From: Joe Kleckner <jkleckner@cheetahchassis.com>
Sent: Tuesday, April 18, 2017 11:38 AM
To: jwilliams@freightlineroofsavannah.com
Subject: Brake Chamber Mounting Position. 788900 thru 788919

Brake Chamber Mounting

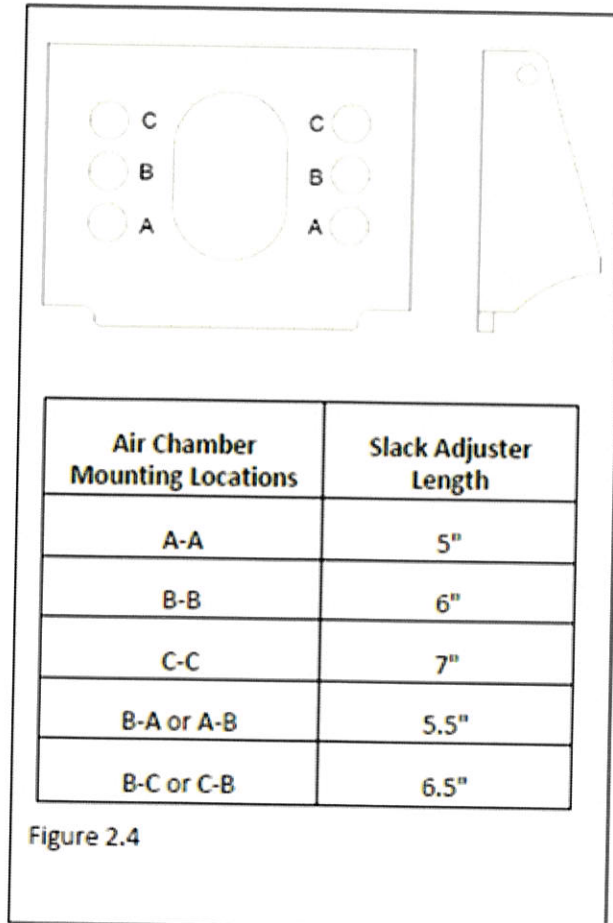
We need your assistance,
Serial numbers 788900 thru 788919, It does appear that the brake chambers may have been mounted in the incorrect position.

The below diagram show where the chambers should be mounted for the slack adjuster length.
Your chambers should be mounted in holes B-A or A-B

Can you please check your units to see if they are installed properly.
If they are not, Please let me know and we can make arrangements to get them fixed properly.

Install the air chamber in the mounting holes in the chamber bracket according to the slack adjuster length required. (Figure 2.4)

You can have your shop guys make these changes and submit a bill for the work.
Or we can make arrangements to get them to a shop to get fixed.
